<b>Title - Sujet</b> TUNNEY'S CHILLERS 1 & 2	
<b>Solicitation No. - N° de l'invitation</b> EJ192-170660/A	<b>Amendment No. - N° modif.</b> 004
<b>Client Reference No. - N° de référence du client</b> 20170660	<b>Date</b> 2016-09-21
<b>GETS Reference No. - N° de référence de SEAG</b> PW-\$\$FG-359-71333	
<b>File No. - N° de dossier</b> fg356.EJ192-170660	<b>CCC No./N° CCC - FMS No./N° VME</b>
<b>Solicitation Closes - L'invitation prend fin at - à 02:00 PM on - le 2016-09-29</b>	<b>Time Zone Fuseau horaire Eastern Daylight Saving Time EDT</b>
<b>F.O.B. - F.A.B.</b>	
<b>Plant-Usine:</b> <input type="checkbox"/> <b>Destination:</b> <input type="checkbox"/> <b>Other-Autre:</b> <input type="checkbox"/>	
<b>Address Enquiries to: - Adresser toutes questions à:</b> Benoit, Marie-Eve	<b>Buyer Id - Id de l'acheteur</b> fg356
<b>Telephone No. - N° de téléphone</b> (819) 420-0720 ( )	<b>FAX No. - N° de FAX</b> ( ) -

**THIS AMENDMENT 004 IS ISSUED FOR THE FOLLOWING REASON:**

- ISSUE ADDENDUM NUMBER 2.

**TUNNEY'S PASTURE CHCP  
CHILLER #1 & #2 REPLACEMENT**

drawing no.: **S2.1-R1**

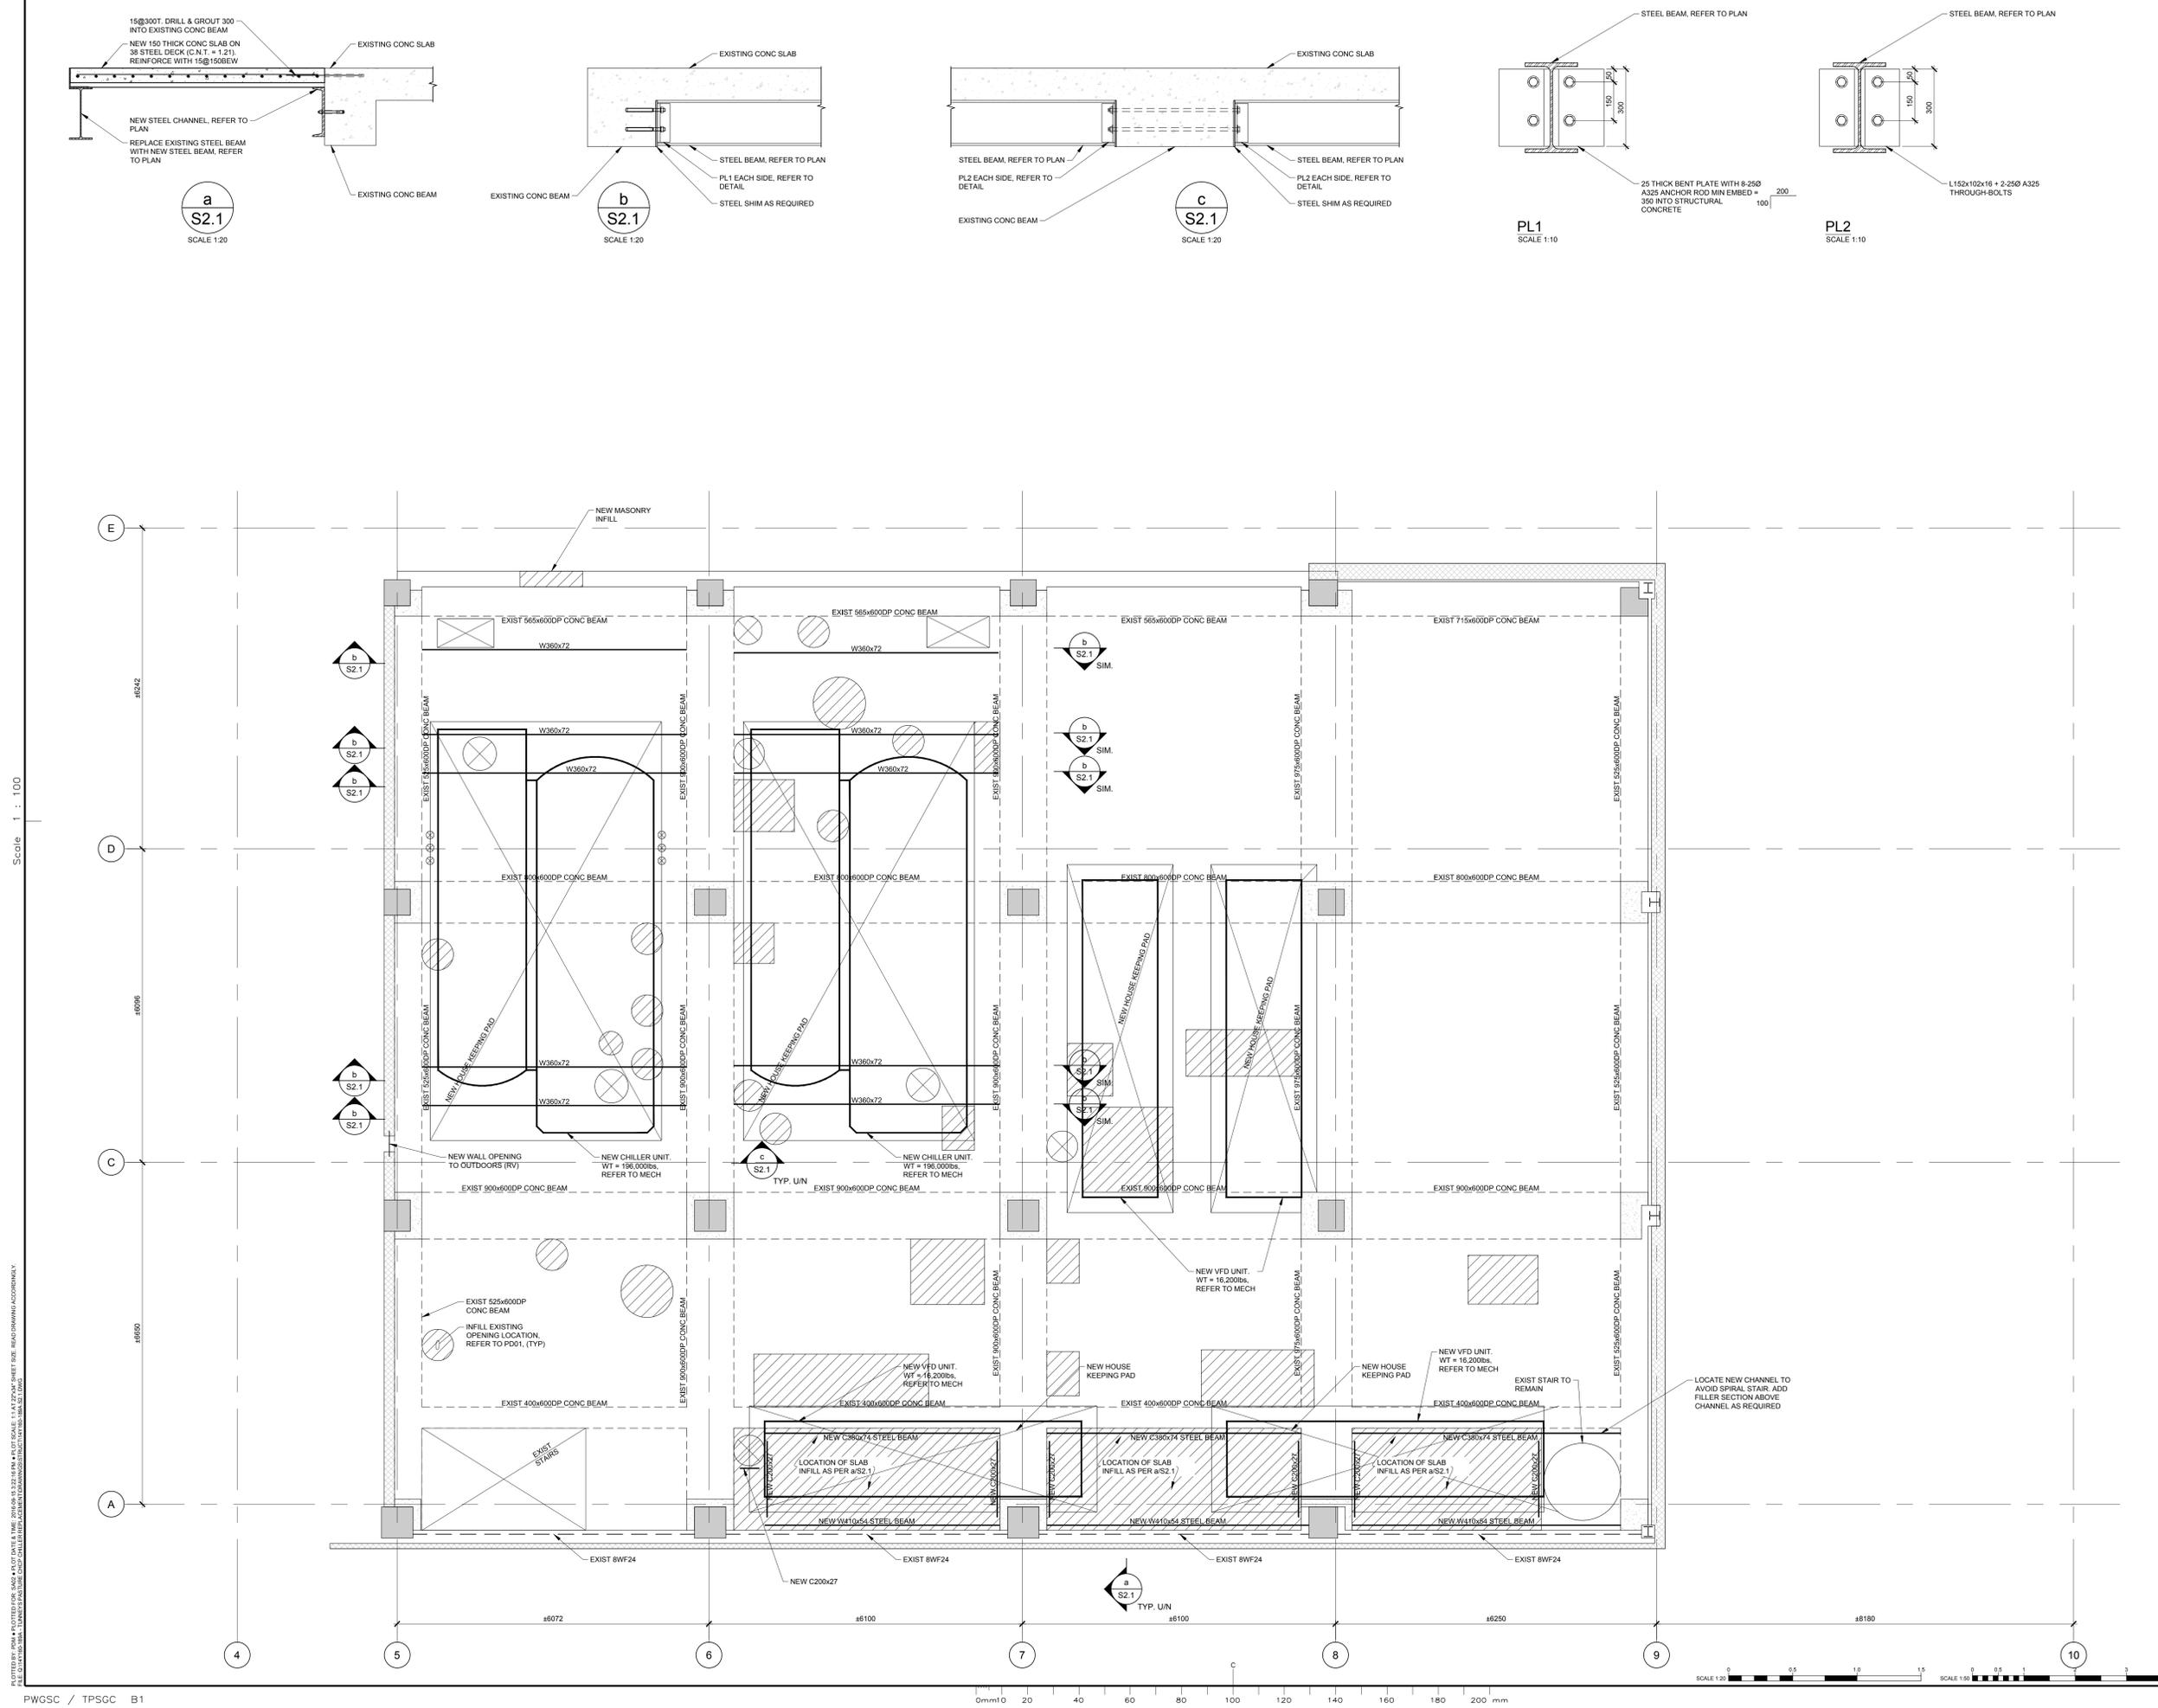
.1 Delete Drawing S2.1 in its entirety and replace with the attached Drawing S2.1/R1 dated September 7, 2016 issued for addendum 2.
